24 August 2026

Minor Change to Development Approval Over Land at 48 Hampden Street, Ascot (Council Ref: A006417693)

3 Proposed Changes

Figure 2 – Approved Vs Proposed Building B Basement 1 Staging Plan

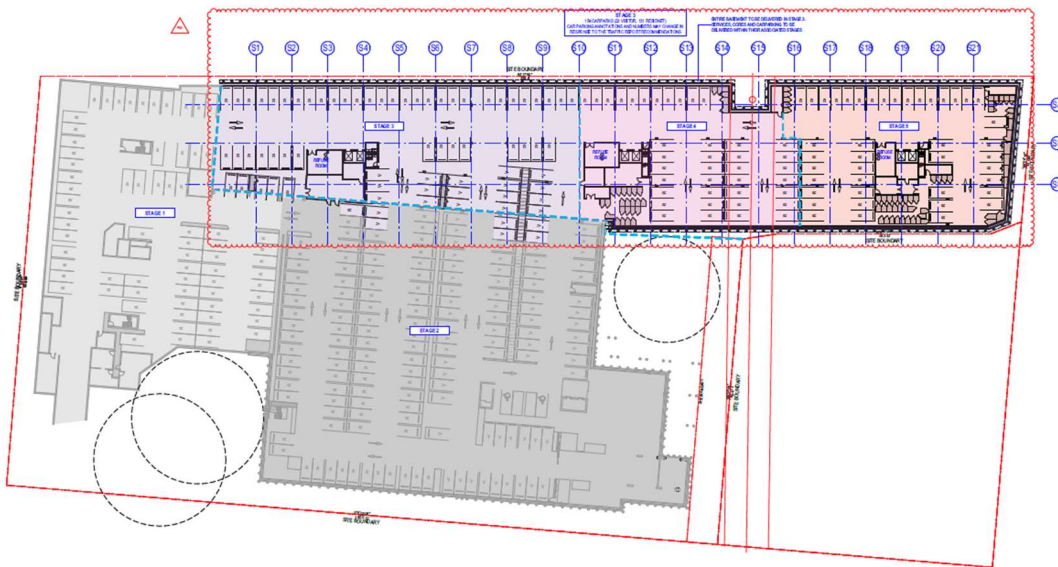
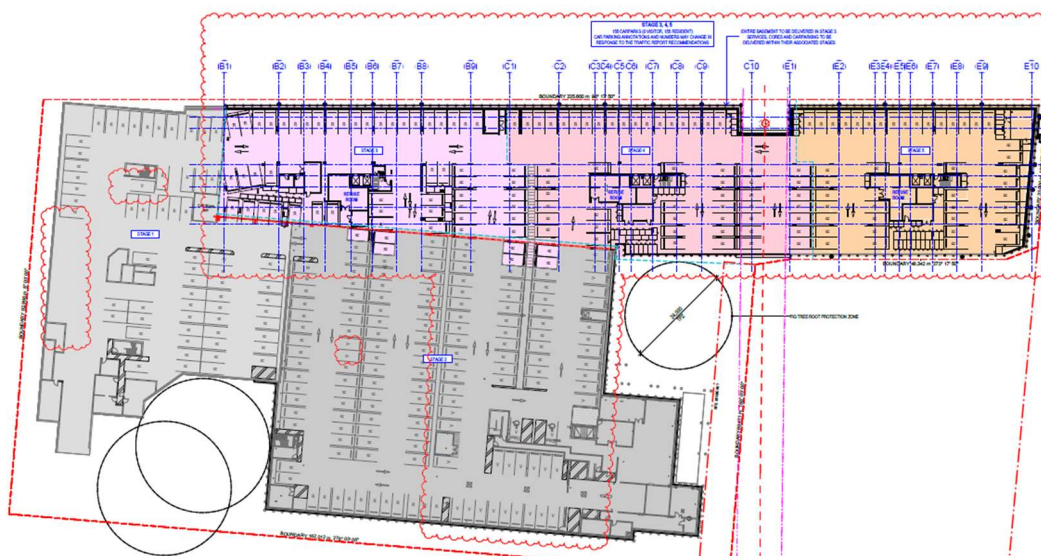
The proposed minor change includes amendments to the approved staging lines within the Building B basement. A marginal adjustment is proposed to the Building B ground staging line to allow for scaffold and safety requirements on the podium level during construction.

The proposed amendments to the staging arrangement are illustrated in **Figure 2** (Refer to **Attachment E** - Plan S1051 – Staging Plan – Basement). The revised staging layout maintains the intent of the approved development while supporting a safe and coordinated construction process.

Figure 3 – Building B West Elevations

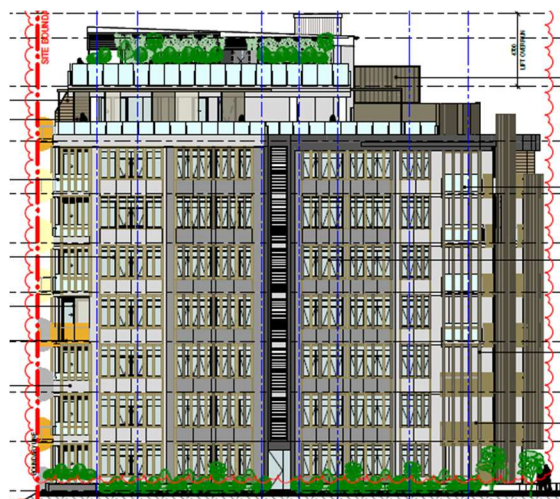
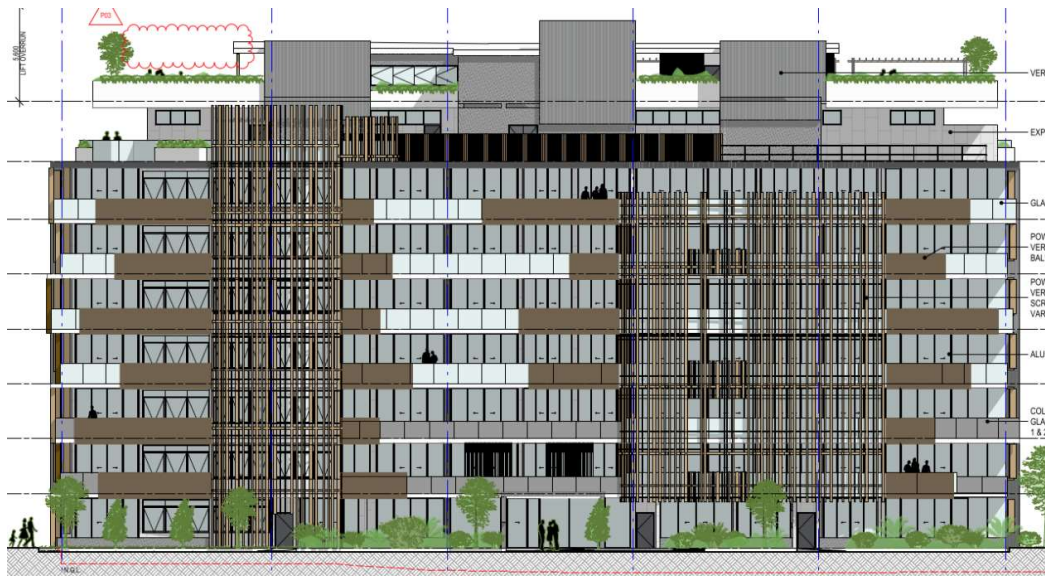
- Basket-weave design development to façade and screening elements;
- Moveable balcony perforated metal panel sun-shading screens to racecourse for resident comfort, privacy and control of solar exposure to Stage 3 (Magnolia House), 4 and 5.;
- Updated screening design and materials, including Level 7 mechanical plant screening;
- Penthouse balcony design and minor extent refinements, including planter bed locations;
- Level 8 rooftop/pergola line, enclosed-space, trees and planting refinements; and
- Level 8 balustrade height increased from 1200mm to 1500mm for protection from wind.

Figure 3 and **Figure 4** illustrate the proposed changes to Building B. Buildings C and E have comparable changes proposed and are shown in **Attachment E**.

Figure 6 – Approved and Proposed Building B Rooftop Level 7 Footprint

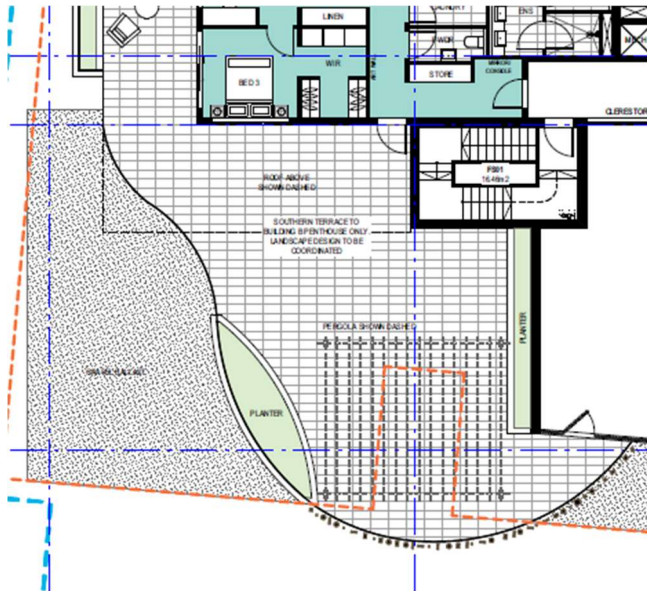
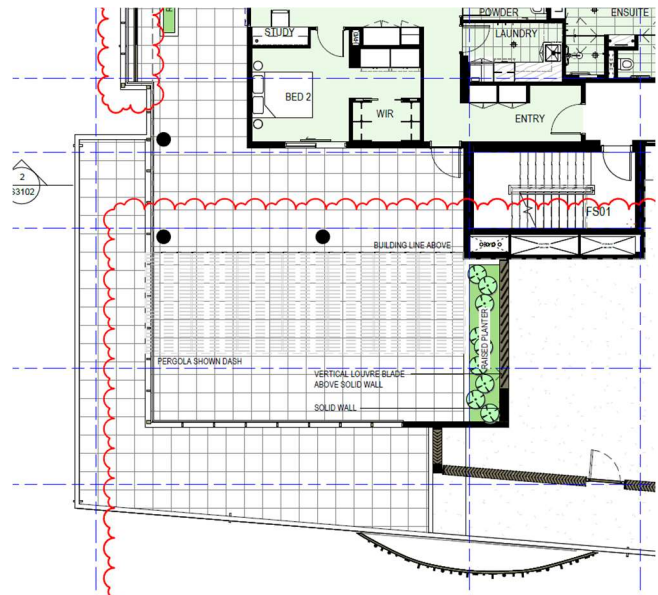
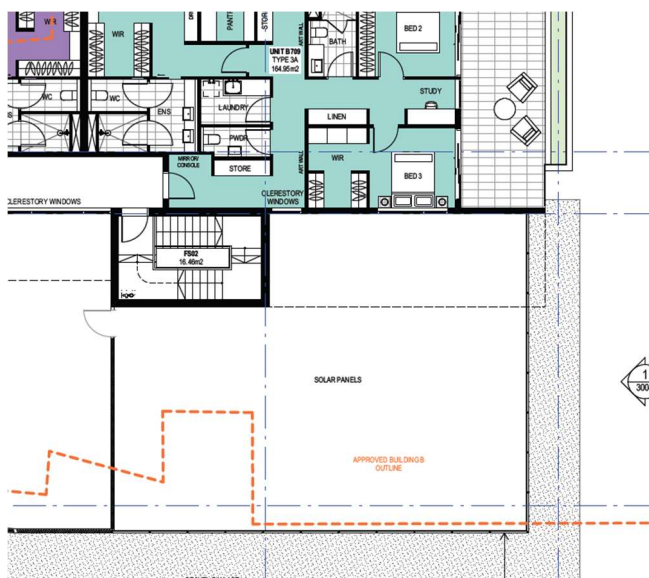
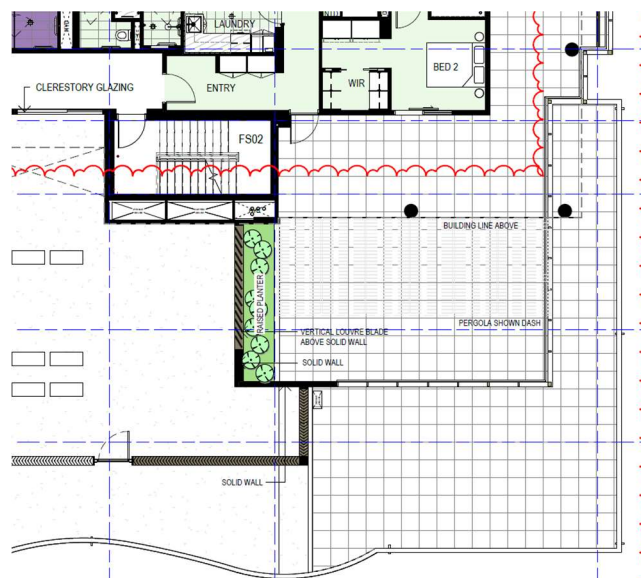
The approved rooftop level included a curved edge profile and dedicated solar panel area. As part of the proposed amendments, the rooftop footprint has been refined to remove the curved edge treatment and adopt a more regular, squared-off form. The dedicated solar panel area is also proposed to be repurposed as additional private open space, supported by landscaped planter areas and a pergola structure above.

The amendments are intended to provide a more practical and functional rooftop outcome for residents while retaining the approved use and overall design intent of the development. The rooftop amendments are not proposed to alter the approved number of dwellings, building height or overall intensity of the retirement village. Rather, the changes are limited to the rooftop level, associated balcony/rooftop areas and very minor internal Level 7 unit layout refinements.

Figure 6 – Proposed Amendments to the rooftop, including trellis planting screen

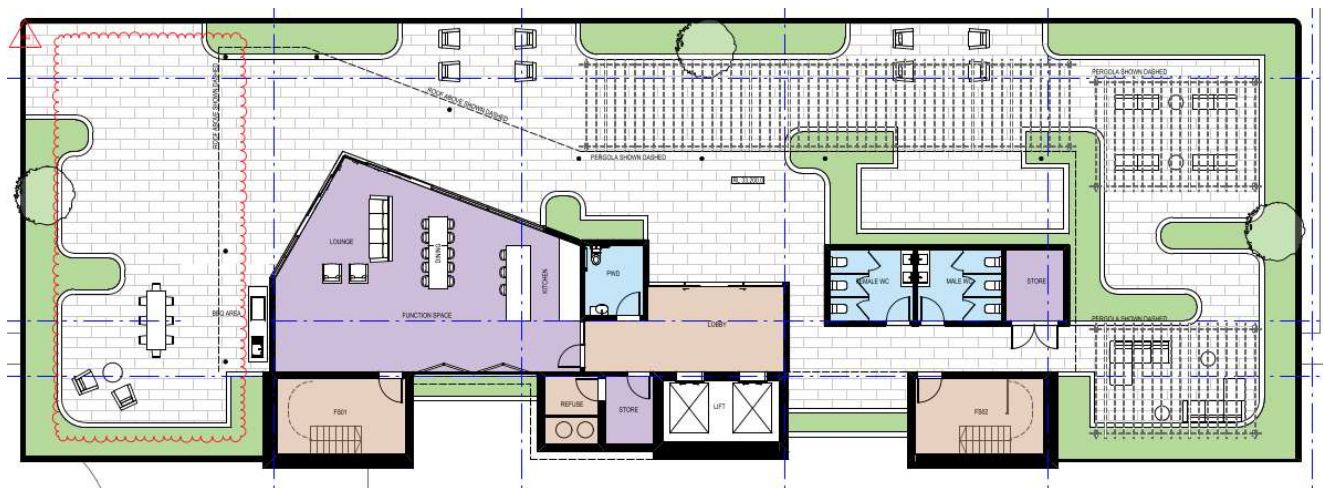
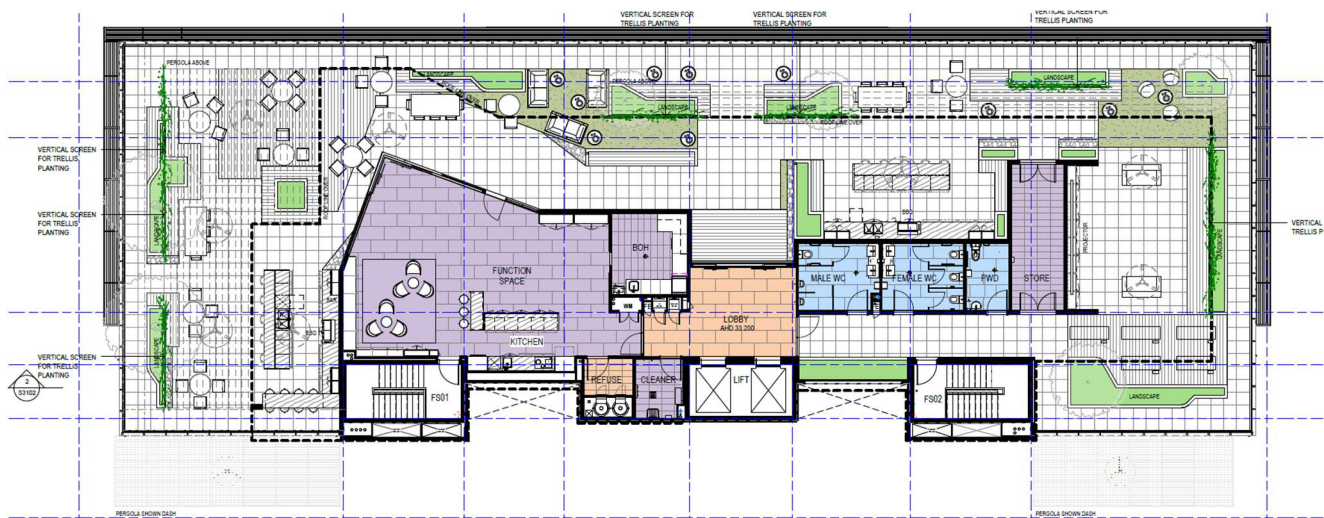
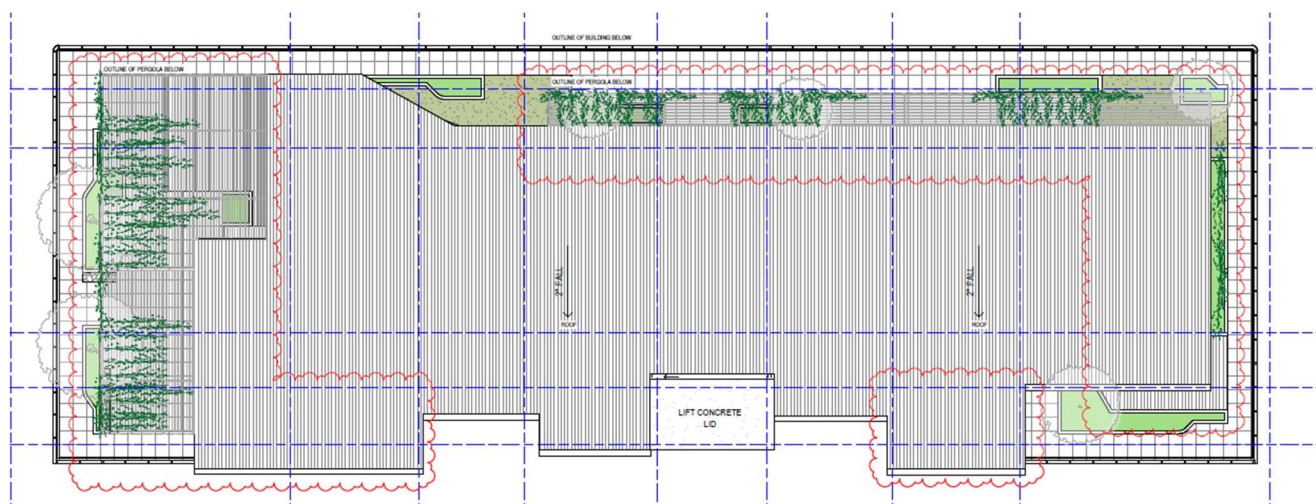
The proposal seeks to amend the approved roof plan of Building B to improve functionality and year-round usability, while retaining the overall design intent of a lightweight structure and building cap. The current approved roof plan comprises a main non-operable roof area and a secondary open pergola structure incorporating non-operable battens. As part of the changes, it is proposed to extend the extent of the main roof area to provide increased all-year weather protection across a greater portion of the roof space.

As part of this amendment, the pergola structure will be retained, however its overall extent will be reduced (Refer to **Figure 6**). This refinement balances the provision of sheltered areas with the continued inclusion of open roof elements and does not alter the broader architectural intent of the development.

The rooftop landscaping has also been modified to improve safety and ensure residents are provided with a range of functional communal facilities suited to their needs. While the arrangement of planting and communal spaces has been refined, the rooftop continues to provide a substantial landscaped outcome and maintains the visual softening of the built form when viewed from surrounding areas. The landscaping has been strategically repositioned to facilitate more direct views to the adjoining racecourse while ensuring planting remains a prominent component of the rooftop design. A vertical screen for trellis planting has also been incorporated as part of the rooftop amendments, providing additional greenery, softening the rooftop built form and enhancing the visual prominence of landscaping across the roof level. The proposed

Figure 8 – Approved and Proposed MRV Occasional Access Vehicle Arrangement

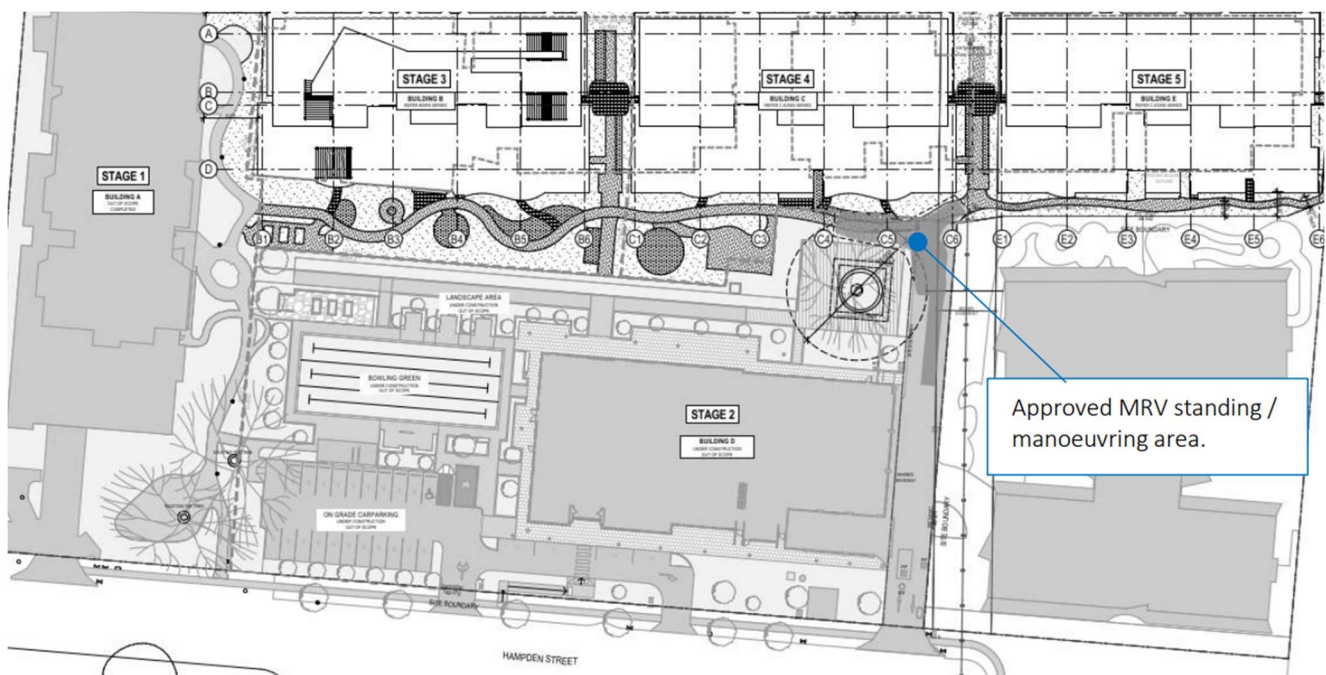
As part of the delivery of Stages 3, 4 and 5, the approved MRV loading area and the internal driveway along the eastern side of Building D will be required for construction access, vehicle movements and associated works. Consequently, the approved MRV loading arrangement is not safe for resident use and cannot be maintained during the construction period for these future stages.

To ensure the continued provision of on-site service vehicle access during construction, it is proposed that the existing refuse collection loading bay located in the south-western corner of the site, adjacent to Building A, be utilised as a temporary MRV loading and manoeuvring area. This arrangement will apply only for the duration of the construction of Stages 3, 4 and 5.

The existing loading bay has been designed to accommodate Council's standard 10.3m rear-loading refuse collection vehicle. This vehicle is larger than, and has a more onerous swept path requirement than, an 8.8m

MRV. Accordingly, the existing loading bay is capable of safely accommodating MRV movements and provides a suitable temporary alternative to the approved loading location.

Figure 11 – Proposed Maintenance Access for Building Washdown (emphasis in green)

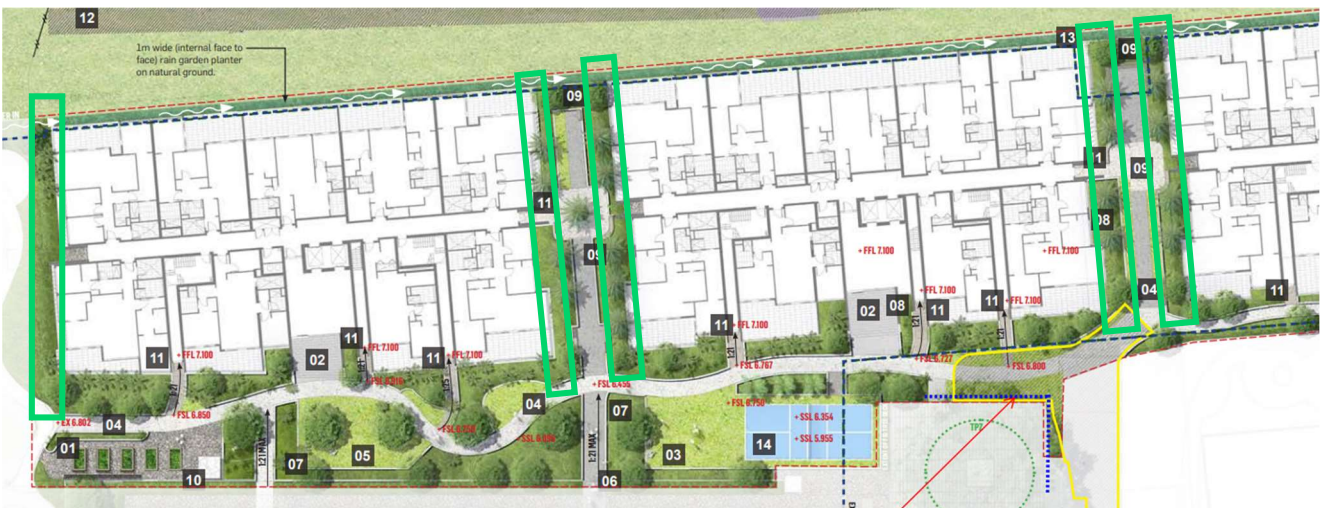
- **Maintenance Access for Building Washdown:** Maintenance access is proposed around the buildings to facilitate routine building washdown and ongoing maintenance. While the extent of some podium level garden beds has been reduced to facilitate this. The landscape outcome is still consistent with the approved development (Refer to **Figure 11**).

Figure 12 – Proposed Maintenance Access for Building Washdown (emphasis in green)

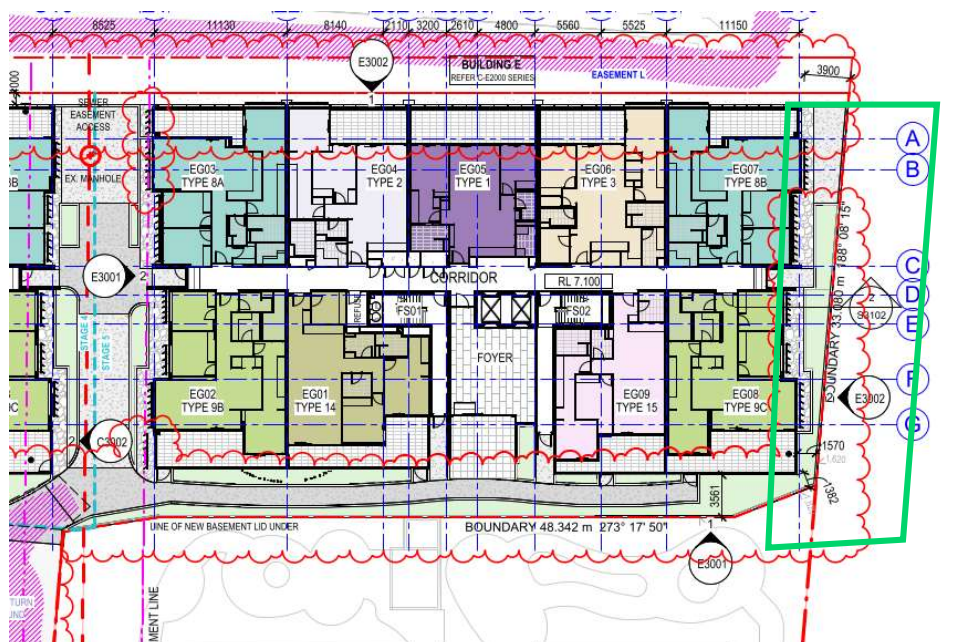
- **Pedestrian Pathway:** The extent of the pedestrian pathway along the eastern edge of Building E has been revised to better reflect the likely travel movements of residents, and remove unnecessary access to improve the privacy of the ground floor unit. The space previously occupied by a pathway will instead be used for additional landscaping.
